## North Burnet/Gateway (NBG) Regulating Plan Amendments

Staff recommendation on the NBG Regulating Plan Amendments in Response to Council Resolution No. 20230504-020

Apply a wider variety of subdistricts to parcels in the North Burnet/Gateway Regulating Plan west of Mopac

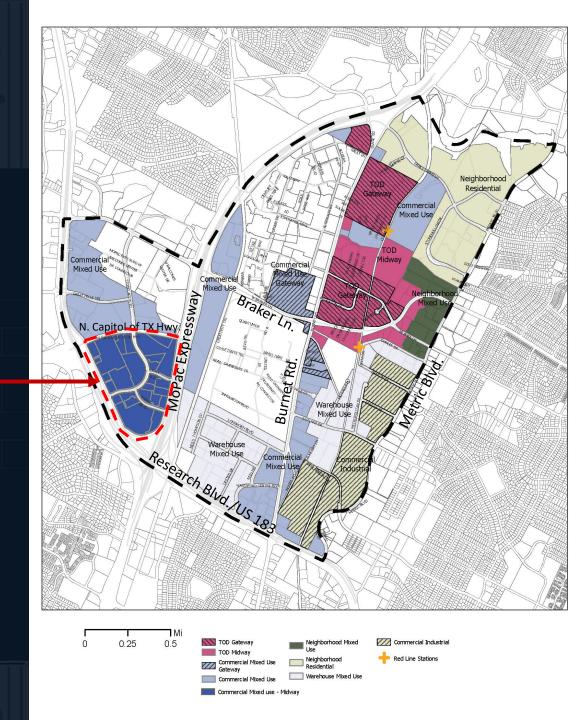
Land use patterns are changing west of MoPac

- 1. Creation of a new Subdistrict: Commercial Mixed-Use Midway (modify Figure 1-2) —
- 2. Applies to certain properties west of MoPac
- 3. Under Tier 1 Development Bonus, would allow up to 350' max. ht. and 10:1 max FAR under CMU-M when using a development bonus
- 4. Allow applicant to request additional height FAR under proposed Tier 2

Eliminate the current requirement for a 30-foot step-back for building facades at the 6th story and above, which limits potential housing developments, retails choices, or office development

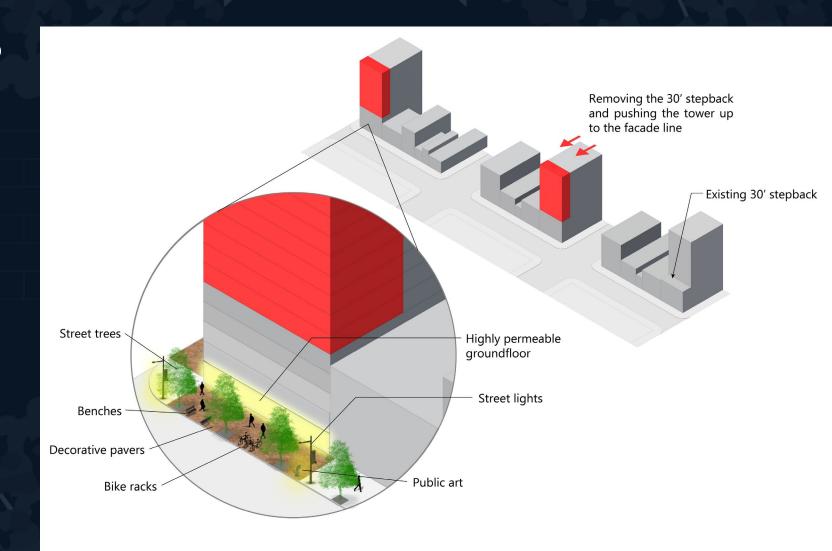
Under the provisions in Figure 4-1 and Article 5.9,a 30-feet step-back is required for all development 6 stories or higher in all subdistricts. The intent was to minimize the canyon effect along certain roadway types and to lessen the scale and proportion impact on the pedestrian next to the public realm. While a step-back an lessen the visual and scale impact of development, it has hampered efforts to increase buildable space for housing. Furthermore, the step-back creates an inconsistent floorplate for parking and garage configurations as outlined in Article 5.8.

Modify reference to 30'-step-back in Figure 4-1 to zero feet. Additionally, modify Article 5.9.

Since the 30'-stepback is being modified, Staff recommends the inclusion additional streetscape improvements with focus on where the building meets the streetscape to create a consistent pedestrian realm as an additional community benefit under the bonus provisions.

Eliminate the 120-foot height limit in the Transit-Oriented Development (TOD), Commercial Mixed Use (CMU), and CMU Gateway subdistricts when adjacent to and across the street from Neighborhood Residential (NR) subdistrict

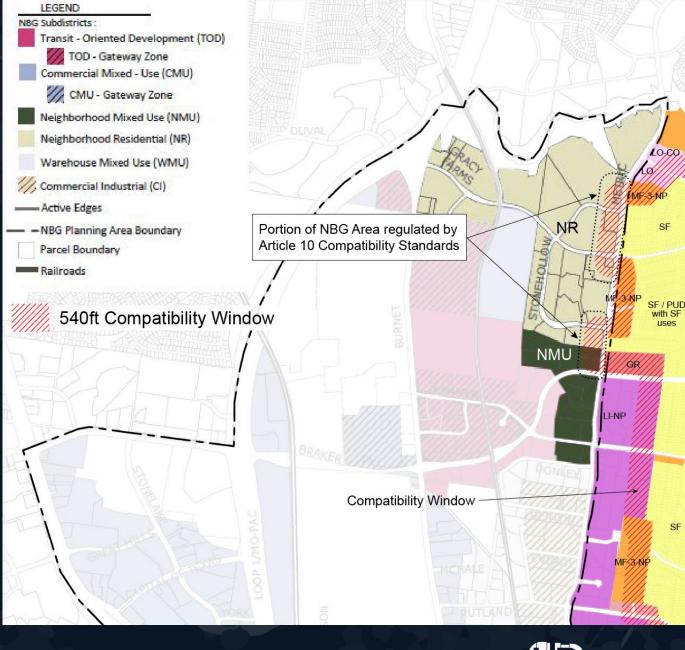
Provisions under Article 4, Figure 4-1, limit height to 120 feet if adjacent to or across the street from NR subdistrict.

Modify provisions under Article 4, Figure 4-1 to remove height limit of 120 feet if adjacent to or across the street from NR subdistrict as the provision has hampered efforts to increase buildable space for housing and clarify development is allowed to use TOD Gateway development entitlements when using a development bonus.
